Monitoring Report
FINAL VERSION
Pen Dell Mitigation Project
Monitoring Year 1
Calendar Year of Data Collection: 2018

NCDEQ DMS Project Identification # 97079
NCDEQ DMS Contract # 6824
Neuse River Basin (Cataloging Unit 03020201)
USACE Action ID Number: SAW-2016-00885
NCDEQ DWR Project # 2016-0403
Johnston County, NC
Contracted Under RFP # 16-006477
Data Collection Period: March-May 2018, Submission Date: March 2019

Under this cover, we are providing the required three (3) hard copies of the Final Baseline Monitoring Report and the Final Monitoring Report Year 1, and the required digital data for each (the .pdf copies of the entire updated reports and the updated digital data) via CDs. We are providing our written responses to NCDEQ DMS's review comments on the Draft Baseline Monitoring Report and Draft Monitoring Report Year 1 below. Each of the DMS review comments is copied below in **bold** text, followed by the appropriate response from WLS in regular text:

Project Name	Pen Dell Mitigation Project
Project ID	97079
Reach ID	R4
Cross Section ID	X6
Field Crew	C. Manner, A. McIntyre

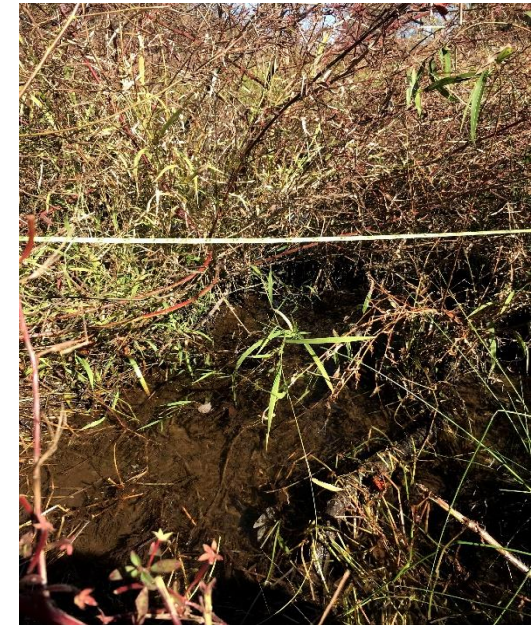
7. **DMS Comment: Geomorph data: XS-6 (riffle) and XS-7 (pool) look like they have changed a bit from MY0. Do you have any concerns about these? Shouldn't the BHR have updated based on this change with the new method?** WLS Response: WLS is not concerned about the adjustments to the referenced cross sections, as it appears to be a minor channel adjustment towards the expected and desired stream dimension and stability. WLS used the new method for calculating adjusted BHRs. The adjusted bankfull elevation using the comparable as-built cross-sectional is approximately one tenth and therefore the BHR would be ~0.9 (<1). The morph table parameters have been updated to reflect this change.

Figure 4

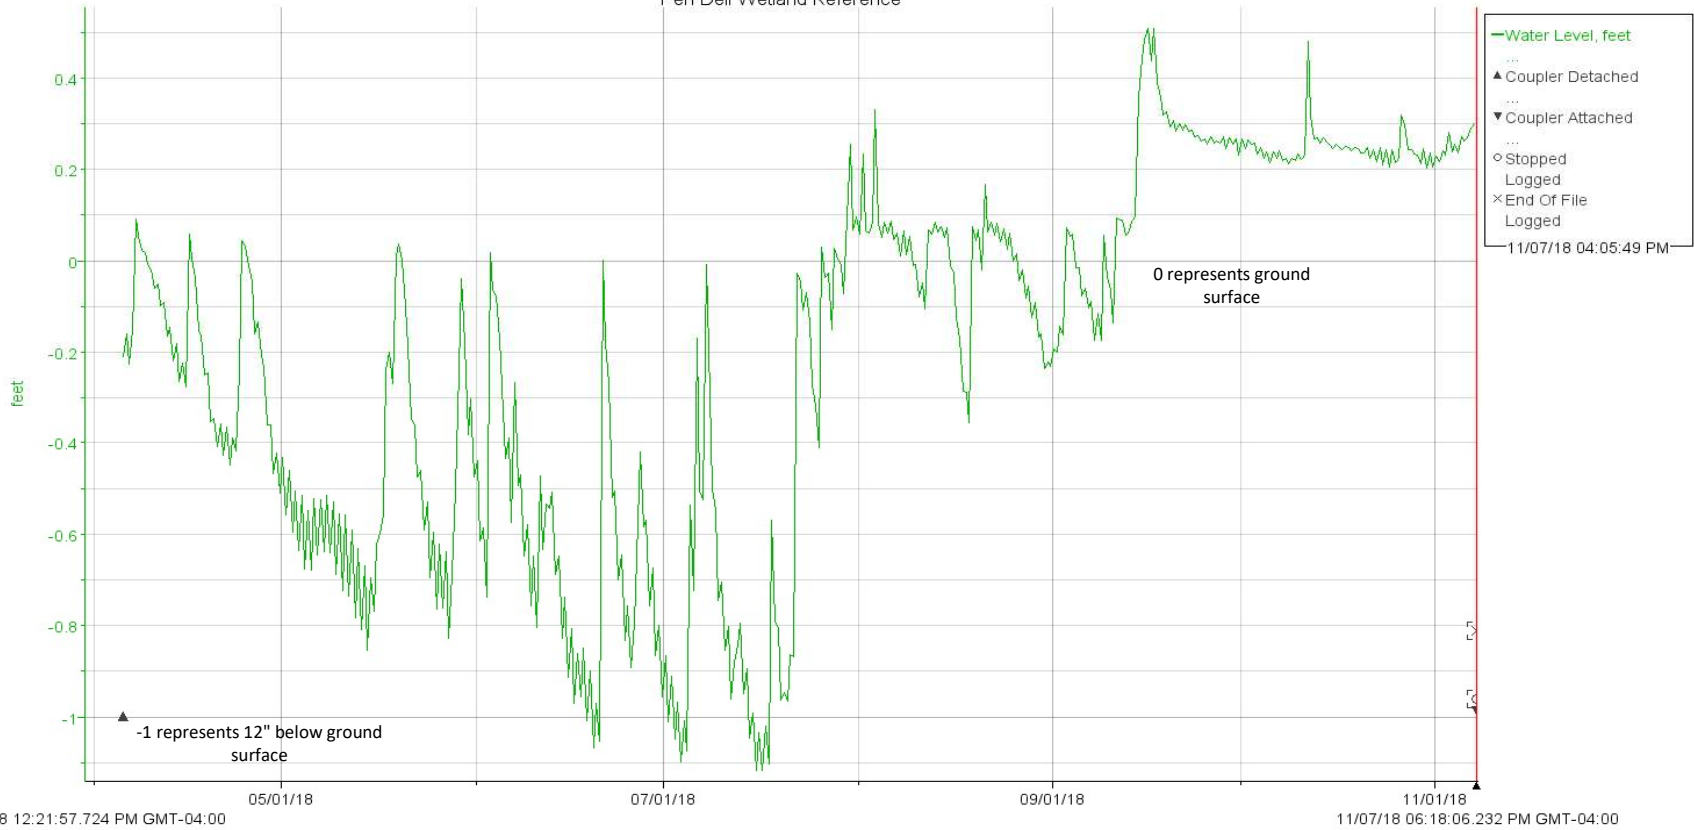
5. **DMS Comment: Page 7, Surface flow data. I don't see this data or Figure 4. Without evidence and monitoring, WLS can't claim flow performance.** WLS Response: This was an unintentional omission by WLS. The flow data and corresponding graph has been added to the 'Hydro Folder' as requested.
